Access Compliance Report

Public Rights-of-Way

Intersection ID: 10018977	Main Street: BLACK_FOX_CT	Cross Street: N/A	Location: S
ADA ID: A62A592AE8BF	Ramp Type: Perp	Initial Pass/Fail: Fail	Overall Compliance: No
		Severity Score: 25

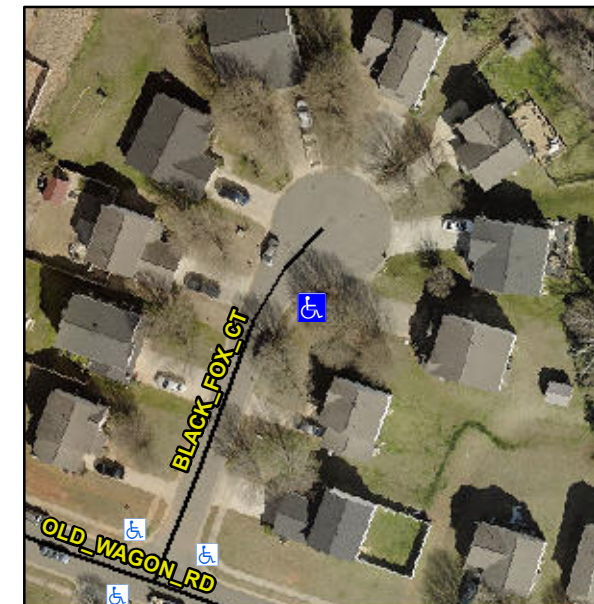
Not Found, R304.5.3

Compliance	Description	Data	Compliance	Description	Data
N/A	Ramp Length (in)	74.0	Yes	Ramp Slope (%)	5.5
Yes	Ramp Width (in)	73.5	No	Ramp XSlope (%)	7.3
N/A	Flare Type LT	N/A	N/A	Flare Type RT	N/A
N/A	Flare Slope LT (%)	N/A	N/A	Flare Slope RT (%)	N/A
N/A	Flare Traversable LT?	N/A	N/A	Flare Traversable RT?	N/A
N/A	Landing Length (in)	N/A	N/A	DWS Provided?	N/A
N/A	Landing Width (in)	N/A	N/A	DWS Contrast?	N/A
N/A	Landing Slope (%)	N/A	N/A	DWS Length (in)	N/A
N/A	Landing X Slope (%)	N/A	N/A	DWS Full Width?	N/A
N/A	Landing Curb? (Y/N)	N/A	N/A	DWS Offset (in)	N/A
N/A	Shared Landing?	N/A			
N/A	Gutter Ponding?	N/A	N/A	Gutter Slope (%)	N/A
N/A	Gutter Lip Ht (in)	1.0	N/A	Gutter X Slope (%)	N/A
N/A	Painted X Walk1?	No	N/A	Painted X Walk2?	N/A
	X Walk 1 Direction	To N		X Walk 2 Direction	N/A
N/A	X Walk 1 Width (in)	N/A	N/A	X Walk 2 Width (in)	N/A
	X Walk 1 Slope (%)	1.0		X Walk 2 Slope (%)	N/A
	X Walk 1 X Slope (%)	1.6		X Walk 2 X Slope (%)	N/A

Remove & Replace Entire Ramp.
